## STAFF REPORT

**REFERENCE:** RM070604

**SUBJECT:** **SUSTAINABLE VENTURES LIMITED – REPORT EP09/07/03 –**  
Report prepared for the hearing of 1 to 3 July 2009

### Vehicle Crossing

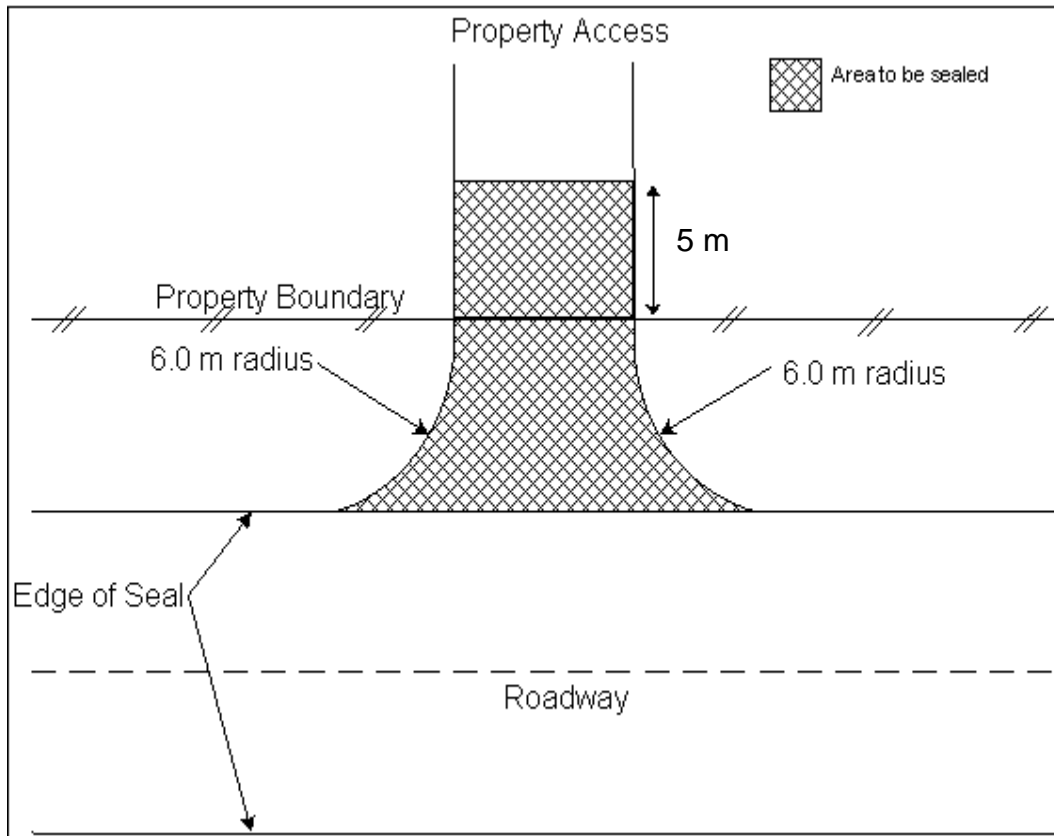
A sealed vehicle crossing shall be formed to service Lot 1 in the position shown on the plan of subdivision.

The vehicle crossing for Lot 1 shall be constructed in accordance with the design shown below:

- a) The access crossing shall be at least 6 metres wide.
- b) the access sealing shall extend at least 5 metres inside the property boundary;
- c) provision of culvert crossings and water tables **where required**. The road culvert shall be to the approval of the Tasman District Council Engineering Manager;
- d) The access crossing shall be sealed in accordance with Tasman District Engineering Standards 2008;
- e) A road crossing permit shall be required from Council's Engineering Department. All works required under this permit shall be fully completed.
